Summary of the JAMA/JAPIA Standard Material Datasheet version upgrade (Ver.2.32)

November 1, 2015
Japan Auto Parts Industries Association
Product Environmental Committee

3. Check specification

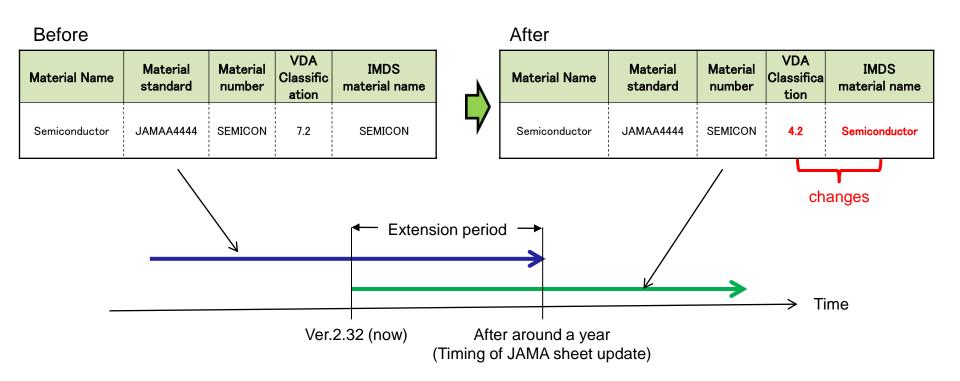
For harmonization with IMDS, a check JAMA sheet's check specification has been changed. (The date of IMDS change is 19th November, 2015.)

Changes in the check condition of the Item "Polymeric Parts Marking" in IMDS

- Range of VDA classification to be checked is changed (only 5.1.x, 5.3 -> 5.x)
- Check of the 25g part weight threshold is removed*

-VDA classification is 5.1.x and over 100g and not yet answered : Error -VDA classification is 5.3 and over 200g and not yet answered : Error

Harmonizing with new IMDS check conditions (Changed parts are shown in Red)

-VDA classification is 5.1.x or 5.4.x and over 100g and not yet answered :Error

-VDA classification is 5.2 or 5.3 and over 200g and not yet answered :Error
